Record of Decision Railroad Dry Cleaners Site Town of Hempstead, Nassau County New York Site Number 130066

March 2008

DECLARATION STATEMENT - RECORD OF DECISION

GROUND WATER COC RESULTS "D" INTERVAL SCREENED 64.3-78.8 ft bgs

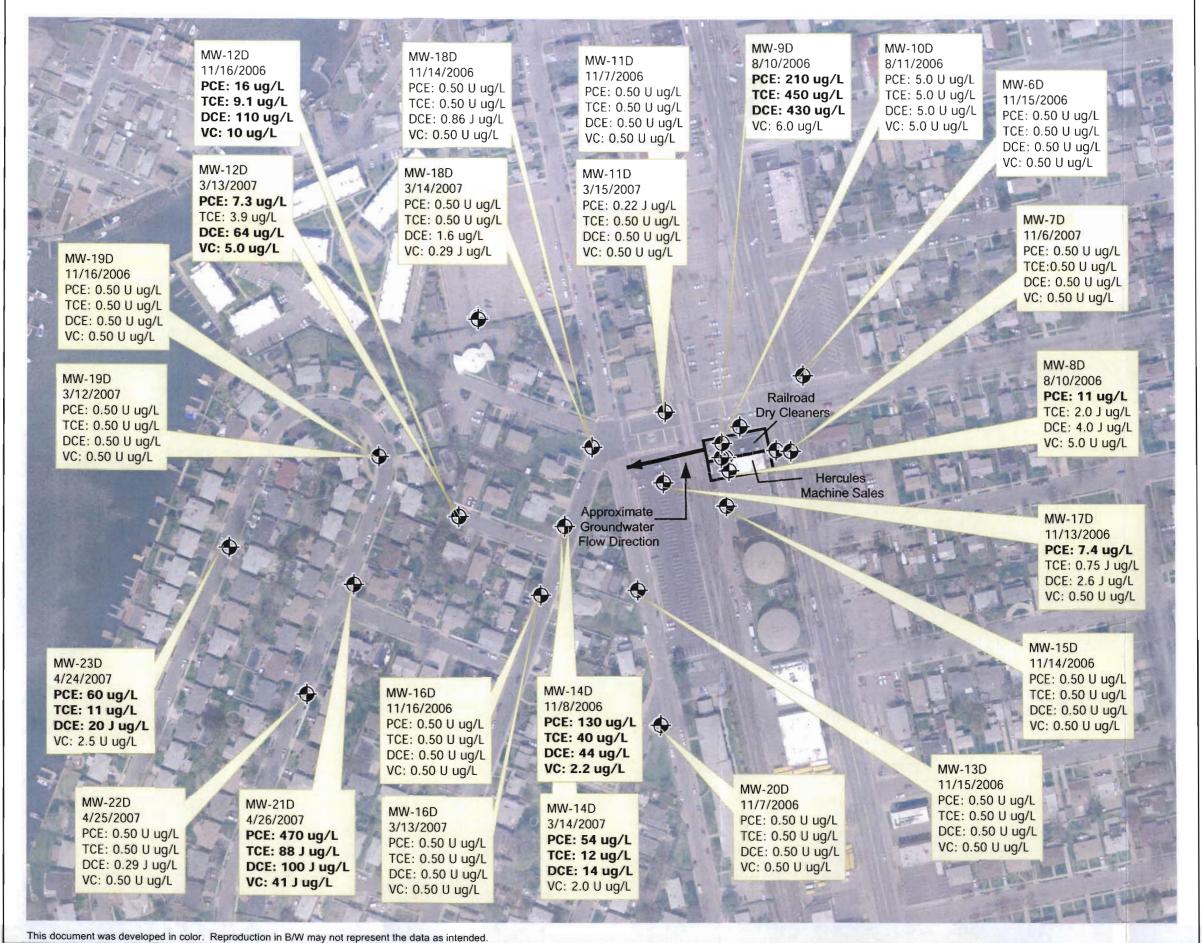
COMMENT 26: Beneath which residential street does the highest level of contamination in the 64.3 to 78.8 deep interval appear?

RESPONSE 26: Shore Road
